Field Report Page 1 of 4

SP&A Project No: 22.331 Report Date: 1.03.2025 Time: 9:30AM Project: Gales Ferry School 1854 CT-12 Gales Ferry, CT 06335 General Contractor: The Imperial Company, Inc. Weather Site Conditions Day of Week Temp. Range: 32°	Field Report No.:												ort No.:	17		
Concrete Site of Nasony 10 Flooring 15 Steel/Misc. Metals 11 Pool Flooring 15 Steel/Misc. Metals 11 Pool Flooring 16 HVAC 22 Tester (Tri-state) Flinishes Temperature 23 Audio Vis/Low Volt SPA in areas where the underside decking is not visible. Name & Location 18 Acceptable SPA SPA in areas where the underside decking is not visible. Roof Ac Cale and Pools and the vertical end points at both sides of the cricket. See attached photo.	SP&A Project No: 2			22.331							Report Date	e: 1.03	.2025		Time:	9:30AM
Temp. Range: 32°		(Gales Ferry School 1854 CT-12 Gales Ferry, CT 06335 General Contractor:									·			
Clear															of Week

Work in progress on the "tower" of roof A

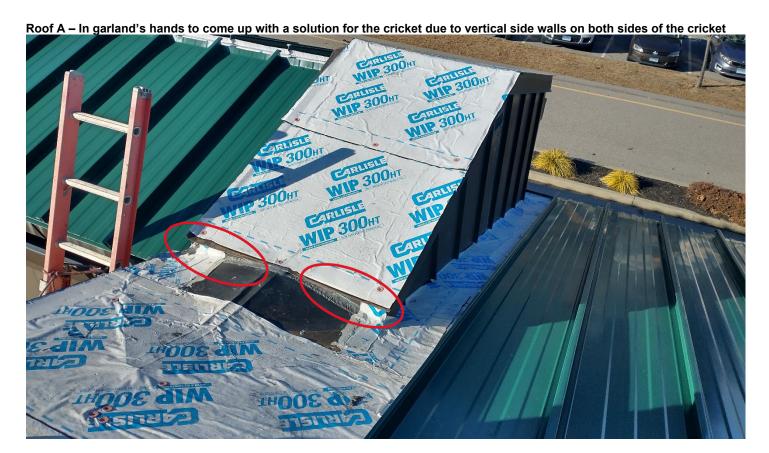
- Installing panels on the "tower" of roof A. See attached photo. General Remarks: - Panels that were installed and have short screws that need to be replaced need to be observed for the correct screw length by Garland & SPA in areas where the underside decking is not visible. - Roof A – Gable end of walkway cover needs the lower 8" of the vertical panels (all three sides) removed for investigation of how to secure the new vertical panels to the existing structure and height requirements. - At the gable end of the walkway roof, Garland needs to produce a drawing eliminating the current cricket for better flow of the rain water. Currently the water hits vertical end points at both sides of the cricket. See attached photo. Visitors: - None.																
 Panels that were installed and have short screws that need to be replaced need to be observed for the correct screw length by Garland & SPA in areas where the underside decking is not visible. Roof A – Gable end of walkway cover needs the lower 8" of the vertical panels (all three sides) removed for investigation of how to secure the new vertical panels to the existing structure and height requirements. At the gable end of the walkway roof, Garland needs to produce a drawing eliminating the current cricket for better flow of the rain water. Currently the water hits vertical end points at both sides of the cricket. See attached photo. Visitors: None.
